E8362B-01B**S E R V I C E****N O T E**Supersedes:
E8362B-01A**E8362B PNA Series RF Network Analyzers**

Serial Numbers: 00000000 thru 46999999

July 26, 2007

Figure 1

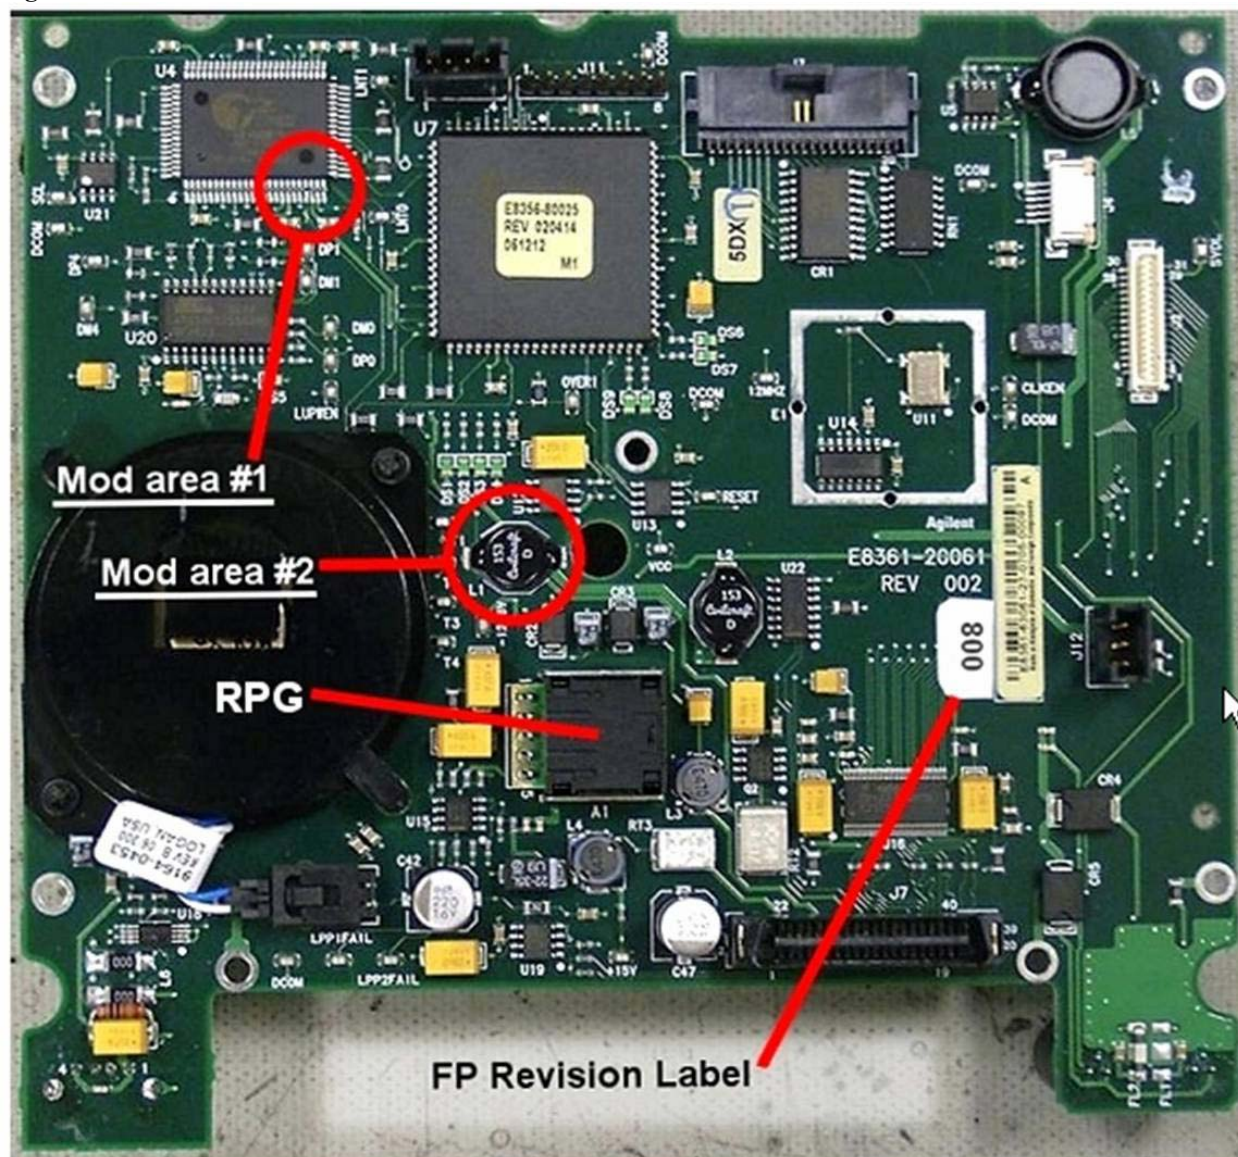
Refer to Figure 1 for the two modification areas to be addressed. Note that while this picture happens to show the FPI board completely removed from the front frame assembly, this is not necessary to perform the required modifications.

- Modification #1 consists of shorting two pins of U4 together with a small amount of solder.
- Modification #2 consist of removing L1.

Unsolder and completely remove the black surface mount inductor L1 from the front panel assembly board. This is no longer needed and can be discarded.

Figure 2

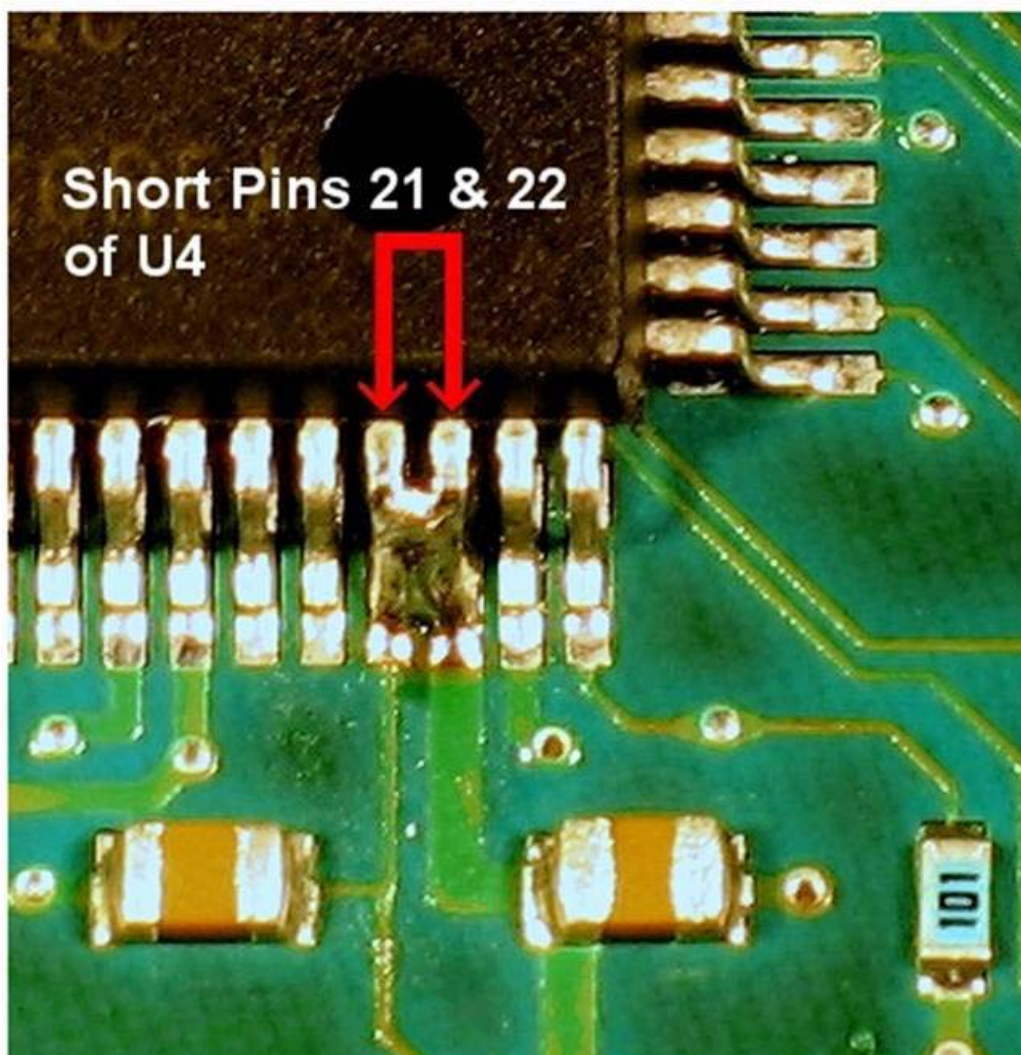
Carefully solder pins 21 and 22 together on U4. Refer to Figure 2 for the exact location. Use care so that no other pins are shorted. Use of a very fine tip soldering iron is recommended and a large work-task magnifying glass is very helpful.
